**REVISED STAFF REPORT AND RECOMMENDATION TO
THE DESIGN COMMISSION**

CASE FILE: LU 21-100992 DZM AD
PC # 21-058331
Choice Cambria Hotel
REVIEW BY: Design Commission
WHEN: January 27, 2022 @ 1:30pm

SITE PLAN C10

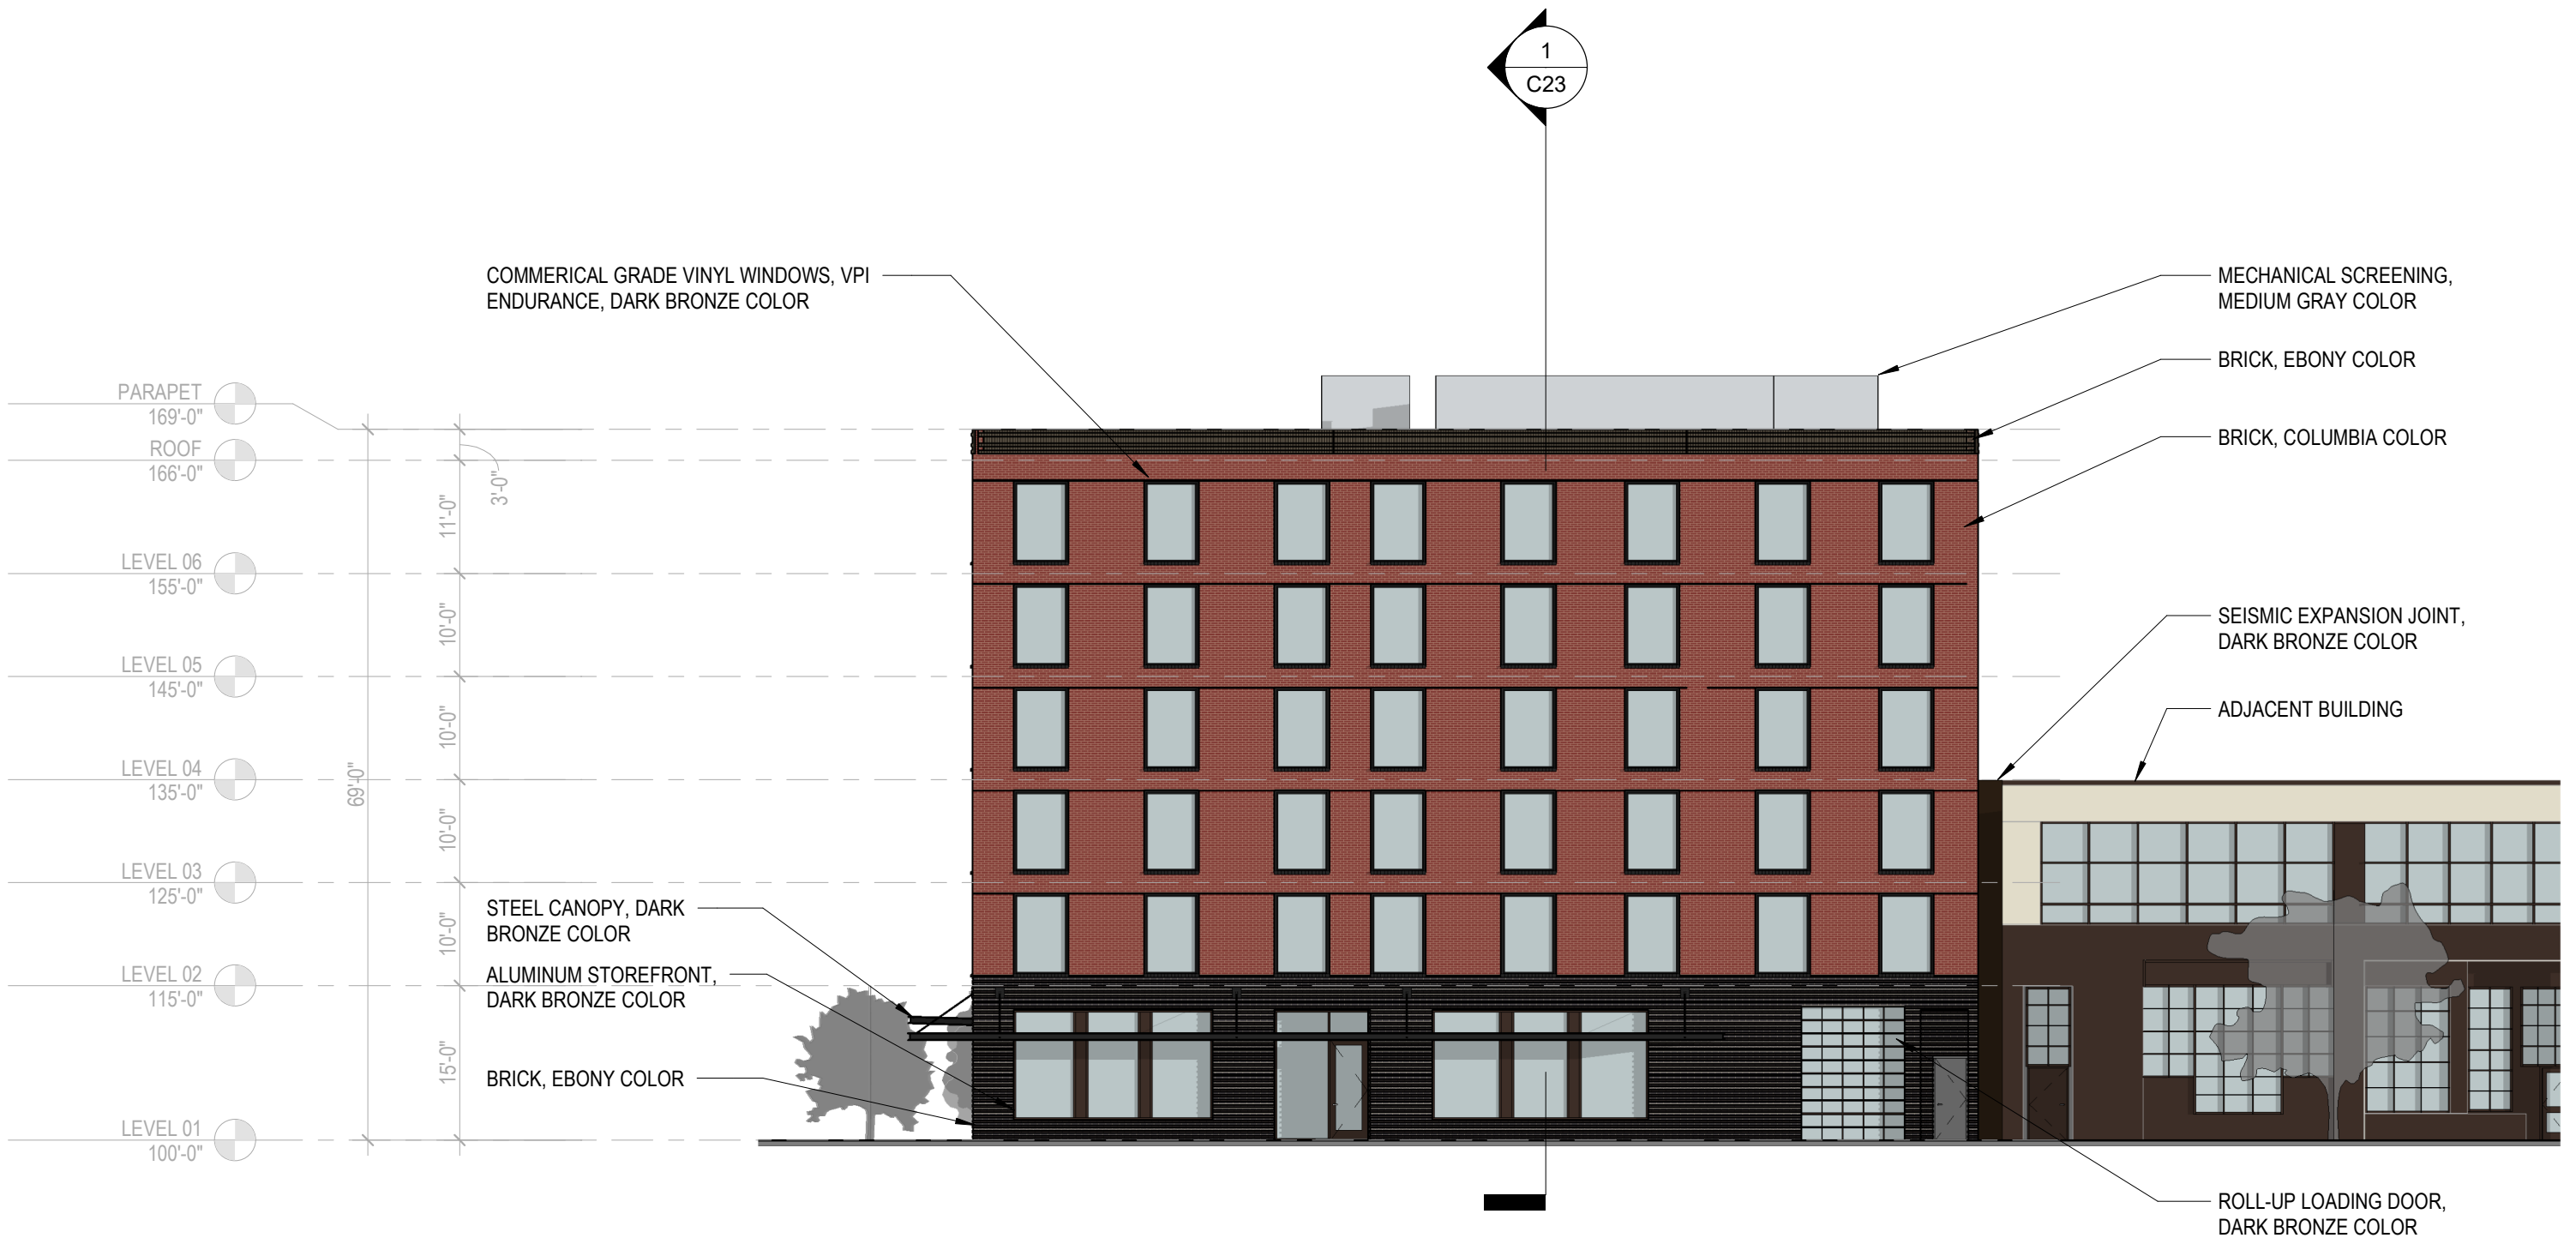
- The applicant requests to provide an approximately 14'-6" deep setback in the middle of the block on the NW Park Ave frontage for approximately 49% of the block length (which equals 98'-0") instead of the required minimum 12'-0" deep setback for 75% block length (which equals 175'-0") . (Note that the current plans show a setback area of approximately 48.7% of the block length [or about 97'-3].)
- The applicant also requests to provide approximately 530 square feet of landscaped area, though drawings show only approximately 453.5 square feet of landscaped area, which is less than the 710.5 square feet that would be required for a setback area as large as proposed. The standard requires a minimum of 50% of the setback area to be landscaped with ground cover and shrubs.

Findings: The Modification to reduce the length of setback area allows for the creation of a building with a central courtyard that better integrates into the context of existing development along the North Park Blocks. The two wings of the building help to retain the existing street wall which defines the western side of the North Park Blocks, where all other existing development is built up to the street lot

Findings: Negative impacts from the proposed modification appear to be minimal or negligible. While the total length of setback area devoted to landscaping and pedestrian areas is reduced, the depth of the area provided is increased to 14.5 feet from the minimum of 12 feet. Additionally, a proposal that met the standard would be required to provide 3 trees. The proposal instead includes 6 trees total in the landscaping area provided, doubling the minimum required by the standard.

1. 33.510.215.B.5, Required Building Lines, Standards for the Park Blocks.
 - The applicant requests to provide an approximately 14'-6" deep setback in the middle of the block on the NW Park Ave frontage for approximately 49% of the block length (which equals 98'-0") instead of the required minimum 12'-0" deep setback for 75% block length (which equals 175'-0"). (Note that the current plans show a setback area of approximately 48.7% of the block length [or about 97'-3].)
 - The applicant also requests to provide approximately 530 square feet of landscaped area, though drawings show only approximately 453.5 square feet of landscaped area, which is

EAST ELEVATION - PARK AVE. C15

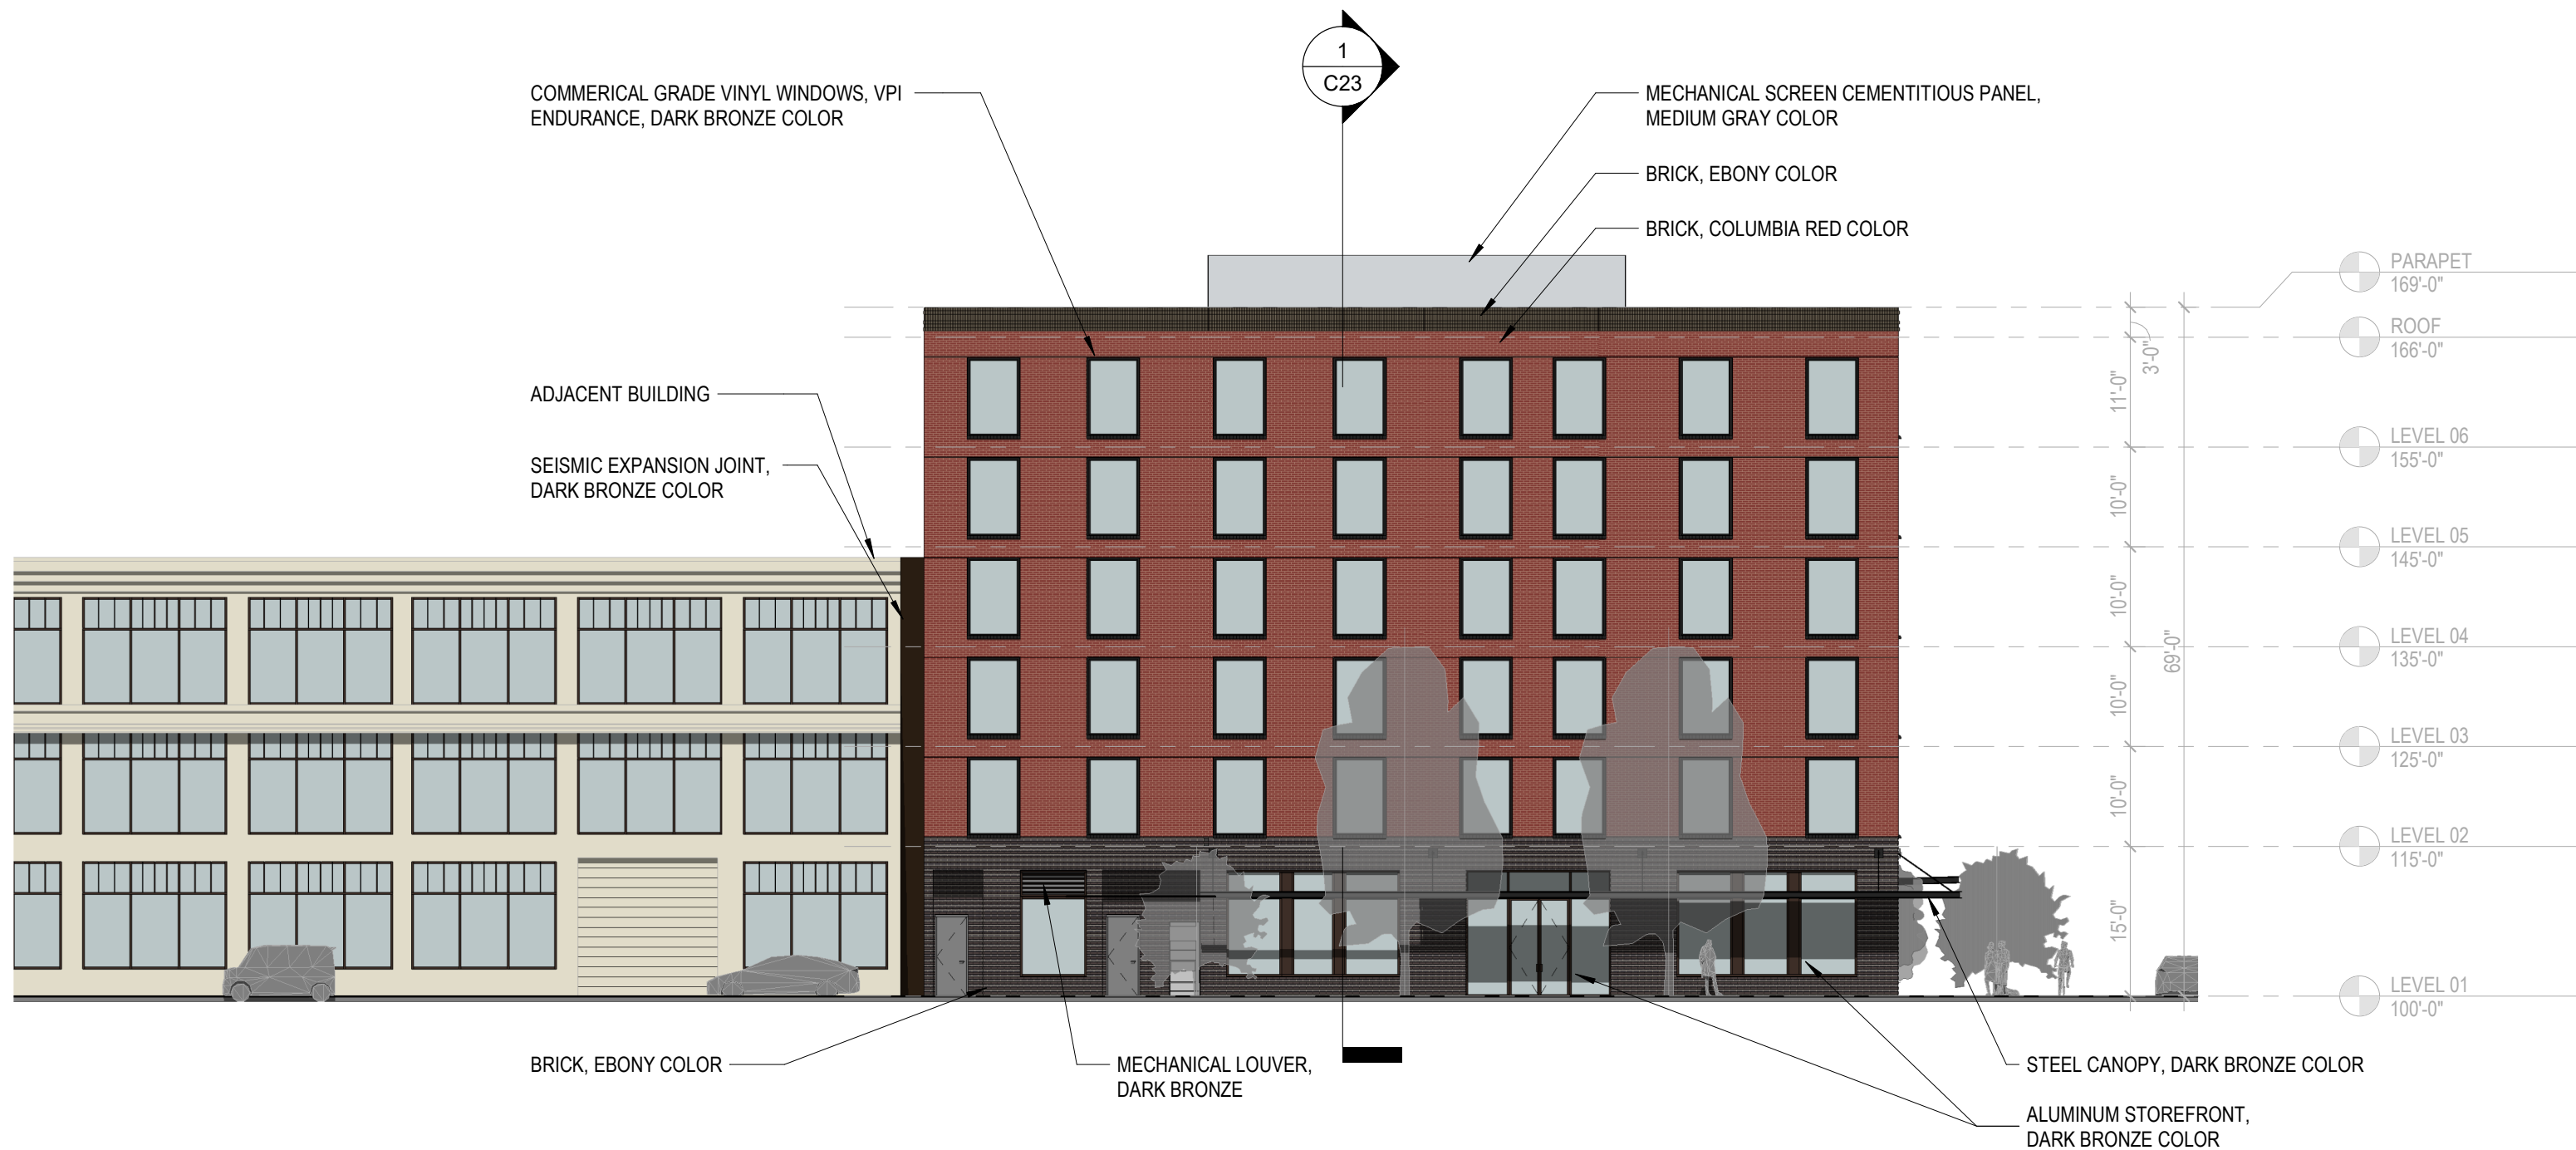
- ☐ Raised planters along NW Park Ave separate the proposed courtyard from the public sidewalk and are low enough to be seen over but still help to create a semi-private exterior courtyard space for the use of hotel and restaurant guests.

- ☐ A large paved area is proposed in the courtyard along the North Park Blocks frontage of the for guest use, socializing, viewing the North Park Blocks, and resting. The area is separated from the sidewalk by a raised planter area, which helps to establish a transition zone between the public sidewalk and the courtyard and which will help to ensure that these activities do not conflict with sidewalk uses.
- ☐ The large paved area in front of the main lobby entrance, with benches along either side of the walkway, will create a good stopping and gathering place and transition zone between the sidewalk and lobby for guests and visitors.
- ☐ Entries into the corner retail space and a secondary entry into the hotel from NW Davis St are recessed, providing small transition areas for people to stop and briefly socialize while entering or exiting the building.

- ☐ Proposed weathering steel at the planters is designed to endure in wet situations. Although this material is generally not desirable at the sidewalk level due to concerns about staining, the weathering steel planters in the building's courtyard are both relatively low in height and sufficiently set back from the sidewalk edge, with a strip of "cobble edging" between the sidewalk and the planter that will provide a space for the steel to weather without discoloring the sidewalk and that will provide a visual and textural guard between the steel and sidewalk edge.

- F. Exposed metal flashings and copings shall be 22-gauge or thicker.
- G. An irrigation system shall be installed in the courtyard planters.
- H. The two eastern Hornbeam street trees along NW Couch St shall be preserved and protected throughout all phases of construction.
